ROOSEVELT ELEMENTARY SCHOOL MODERNIZATION

2324 VERDE STREET
FOR
BAKERSFIELD CITY SCHOOL DISTRICT
BAKERSFIELD, KERN COUNTY, CALIFORNIA

TITLE SHEET, SHEET INDEX & VICINITY MAP

NOT TO SCALE
1
E1.10

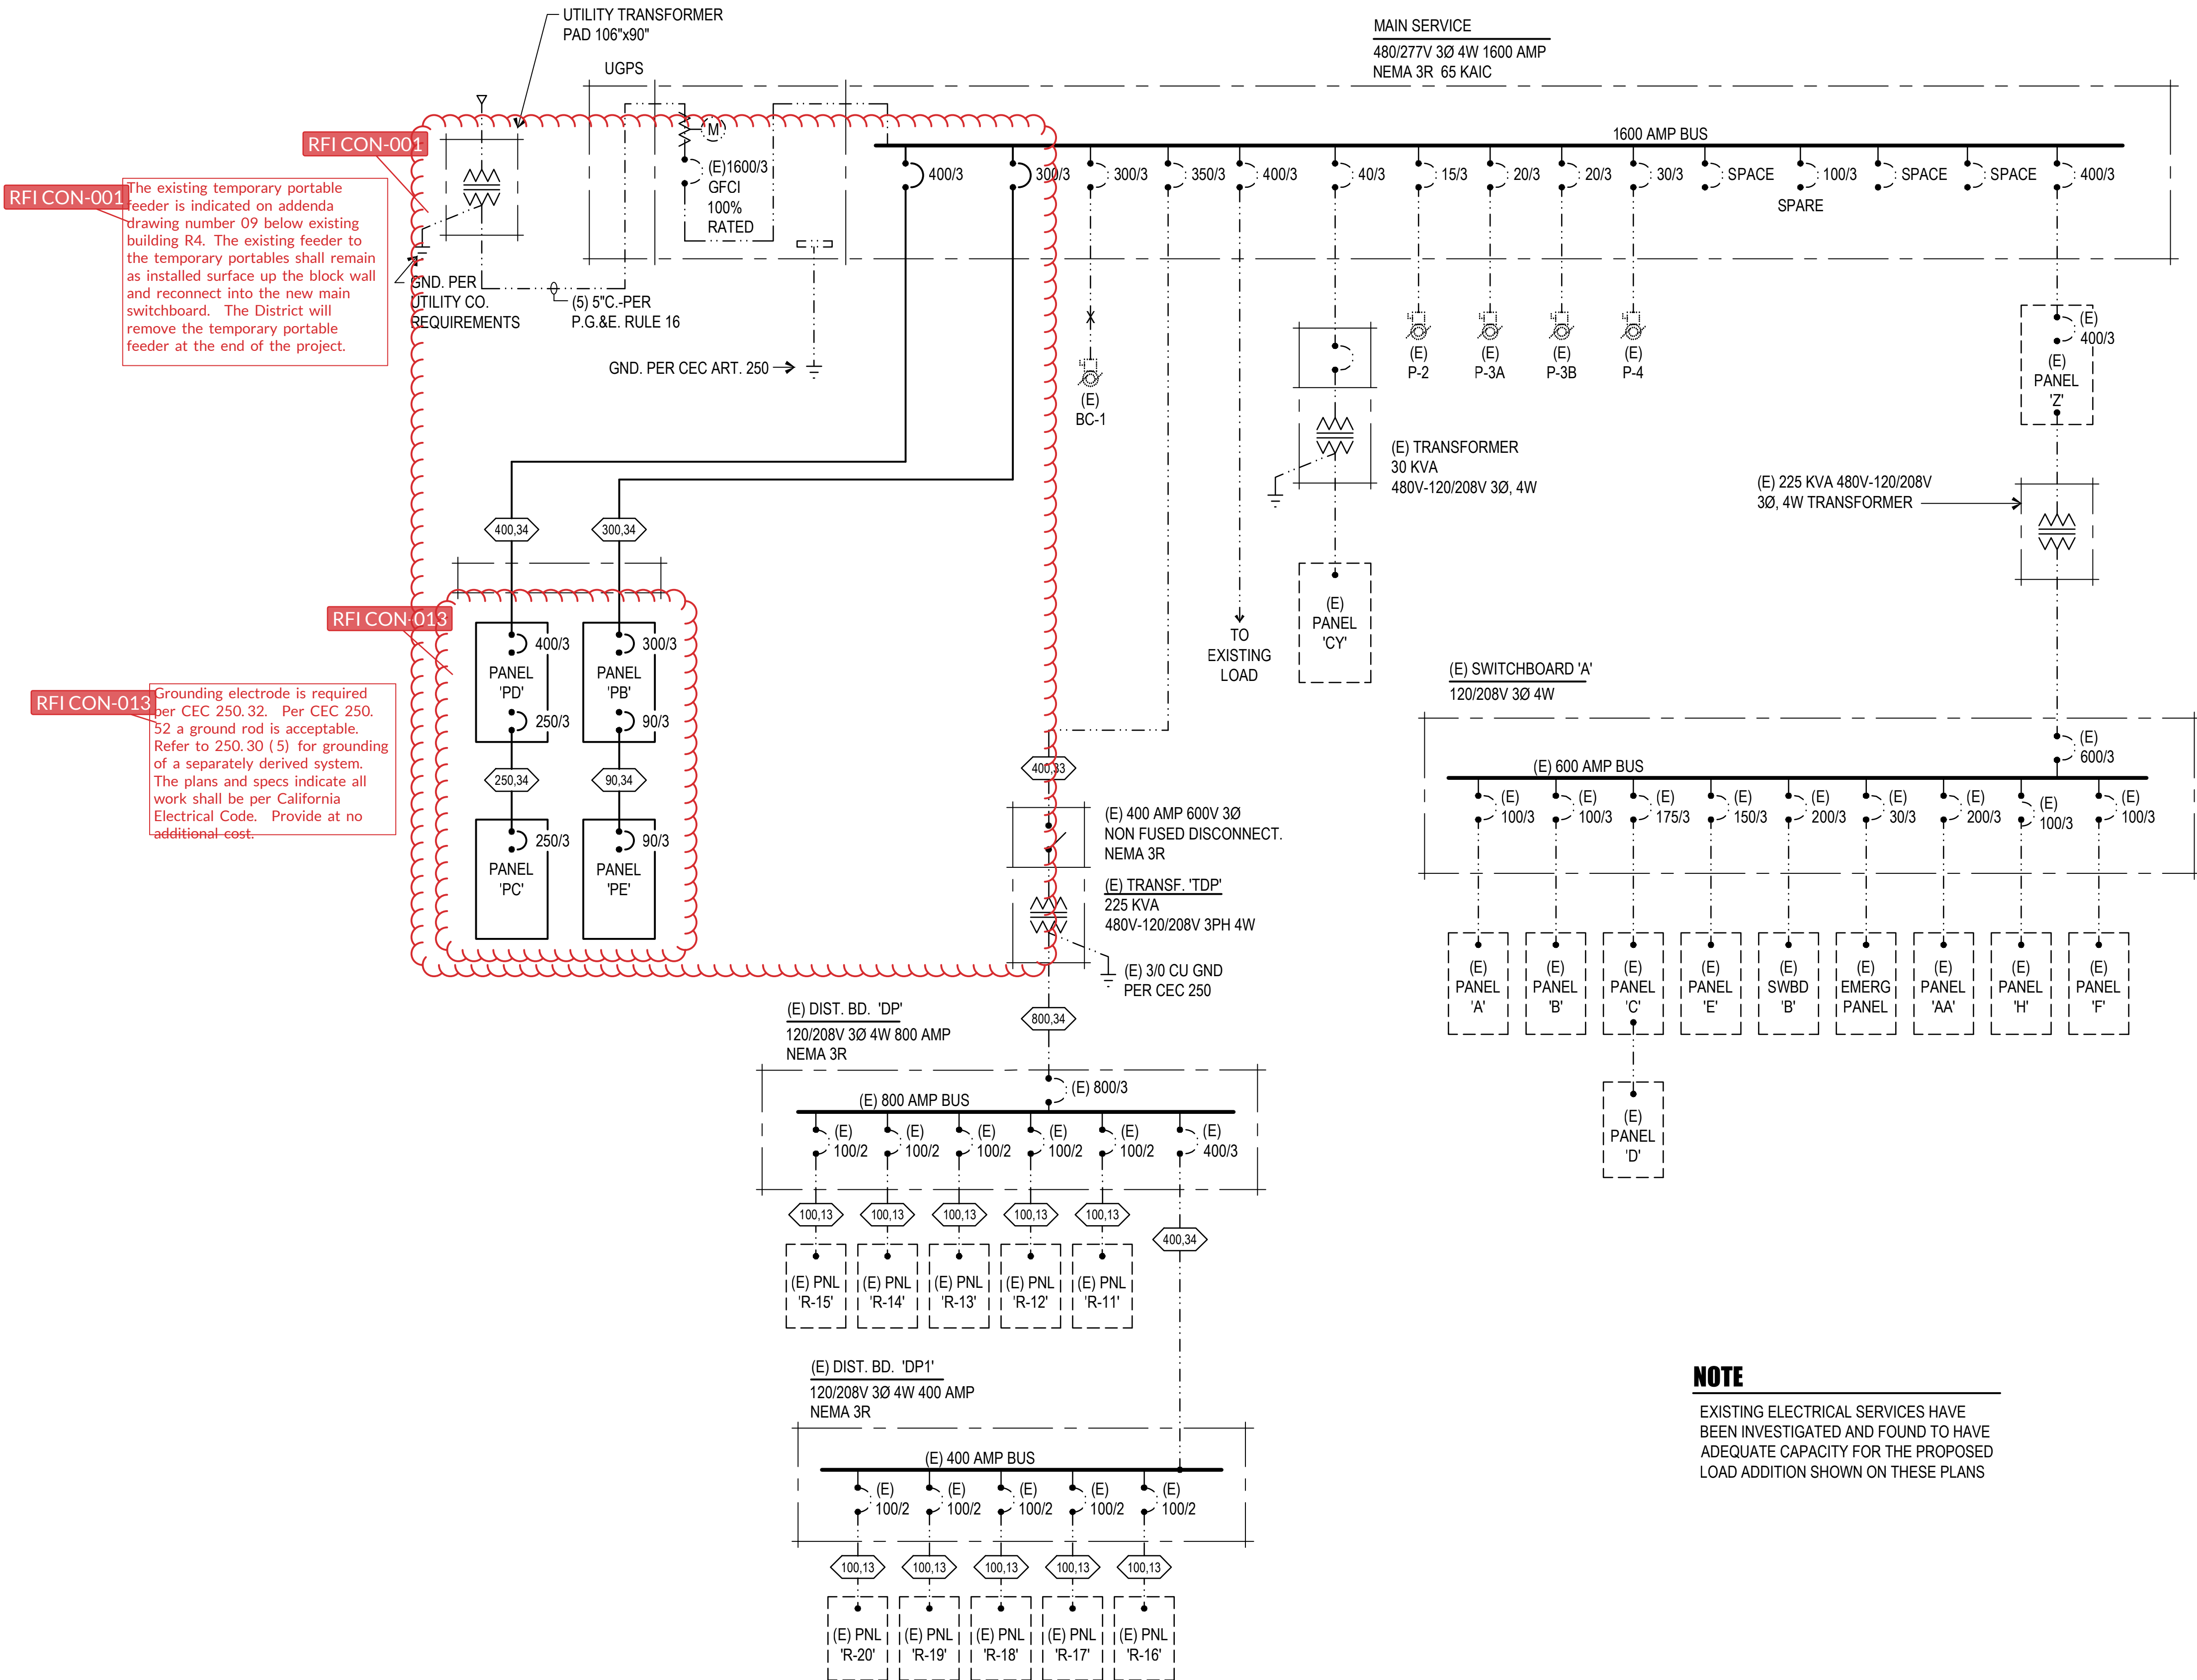
MSB Mounting Detail was not included in original set.
Please see RFI-033 for information and installation.

FIRE ALARM FLOOR PLAN
BUILDING 'E'

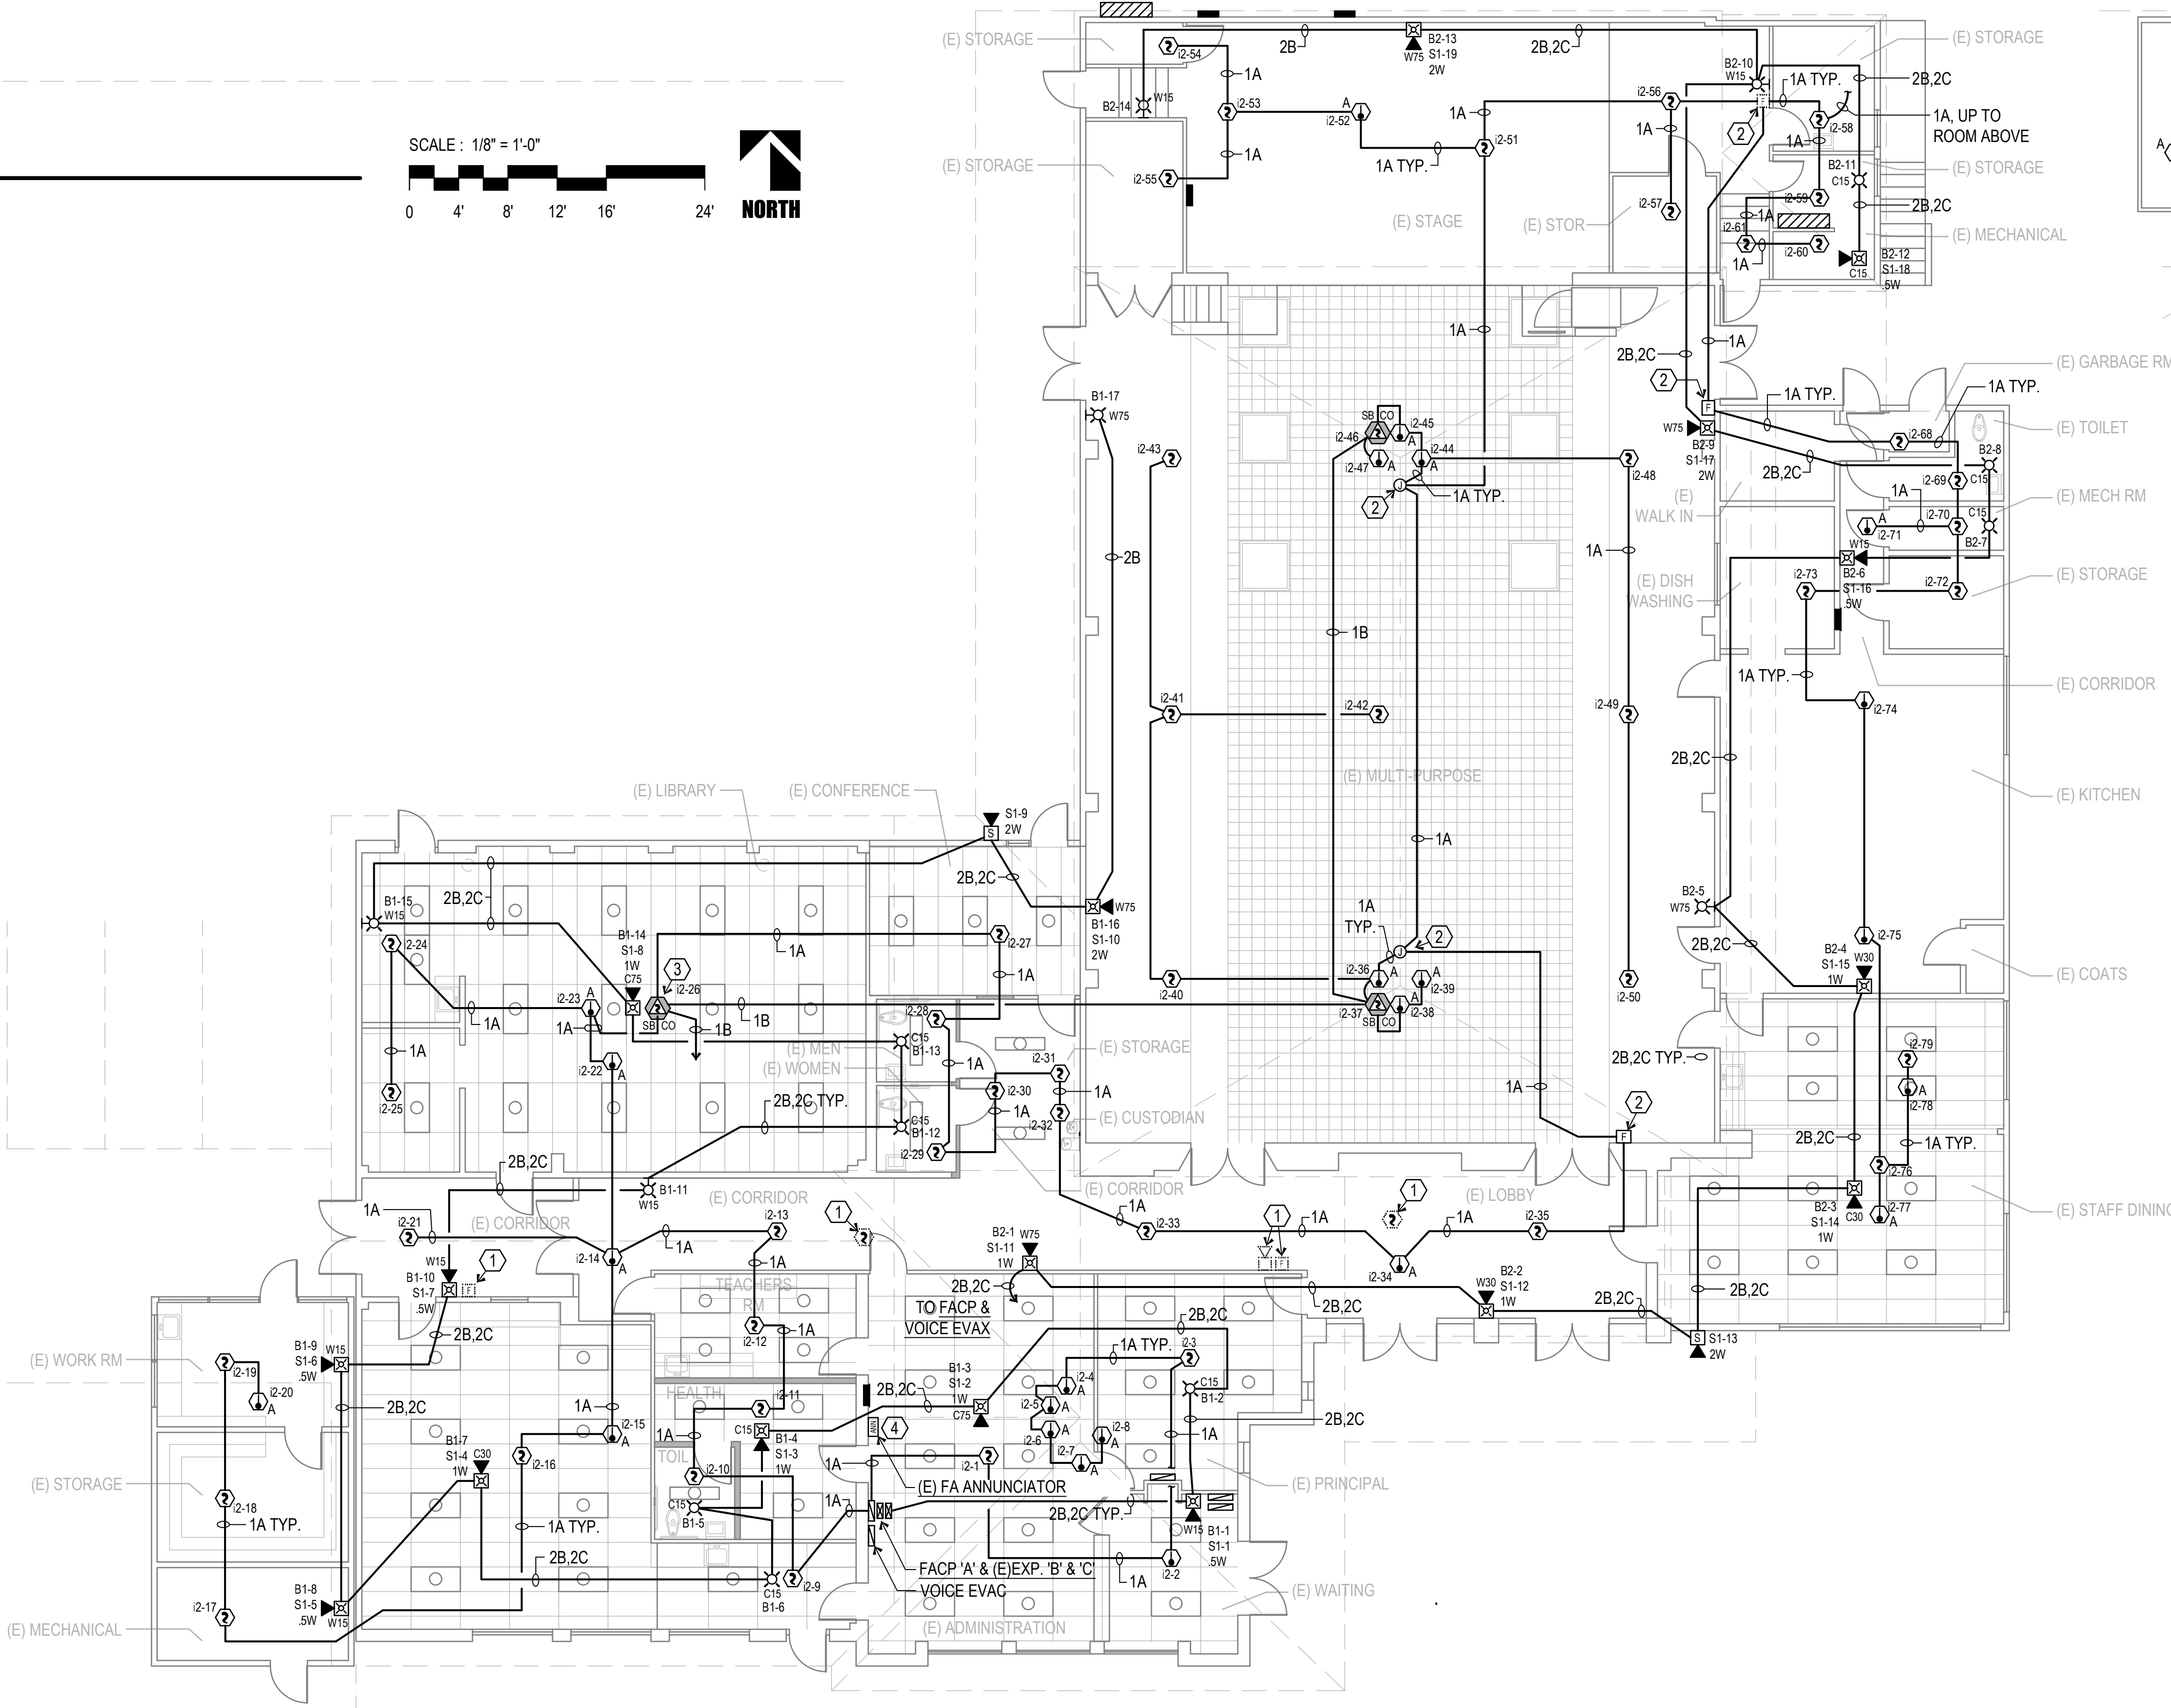
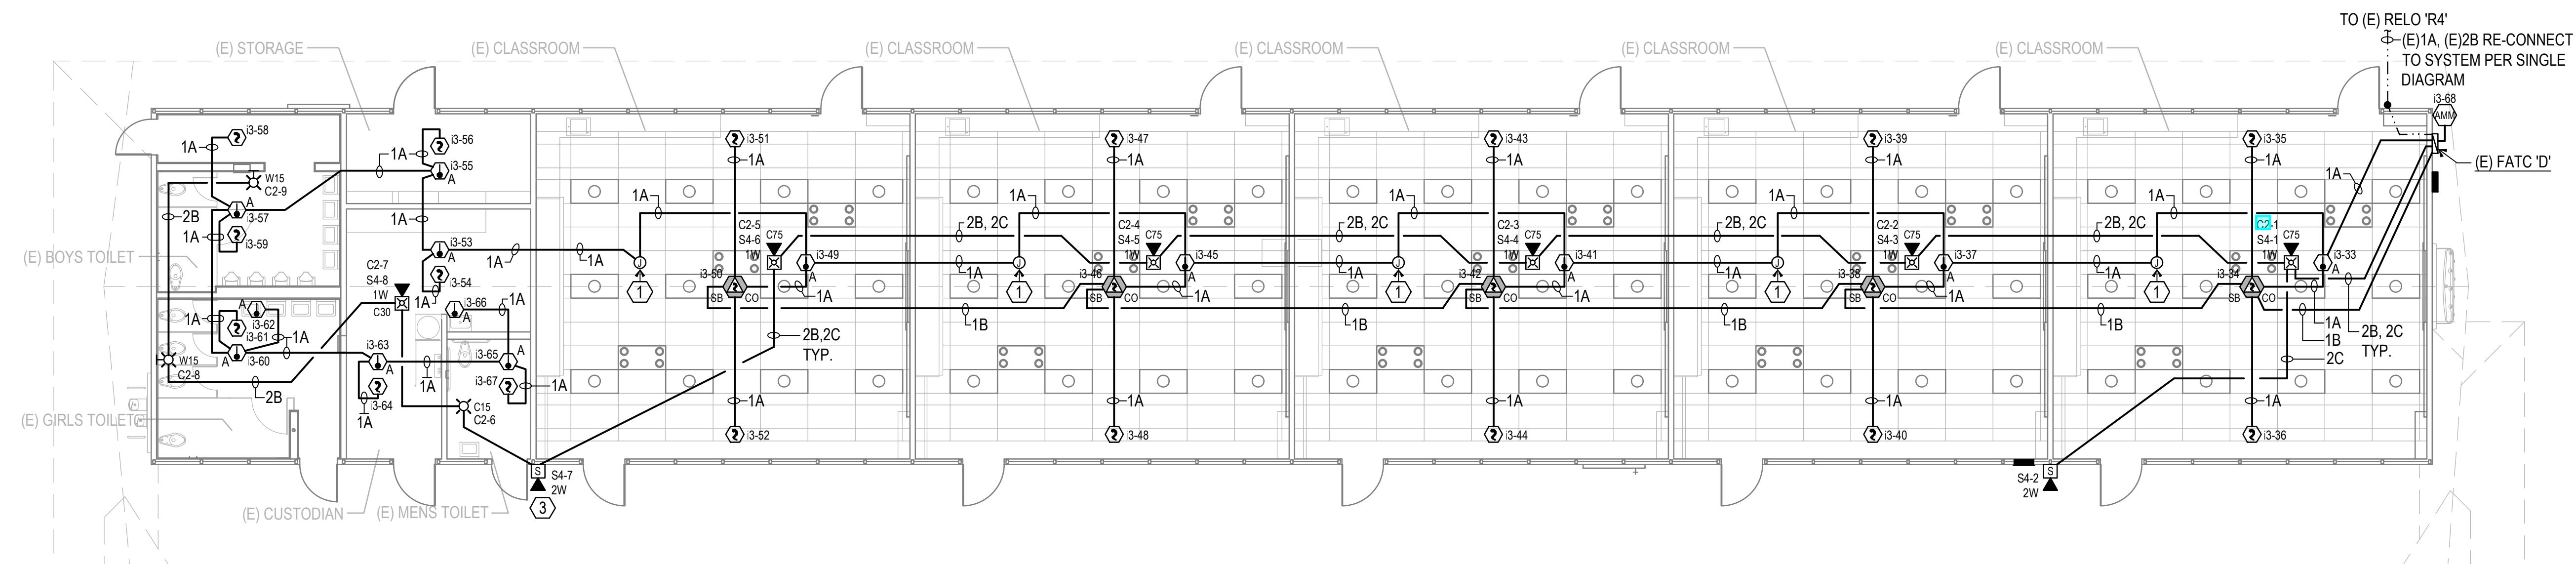
RFI CON-026 | Sheets: E4.10
FIRE ALARM ENGINEERING -
EXISTING CONDITION DISCREPANCIES
PER RFI-026 (06/06/25)
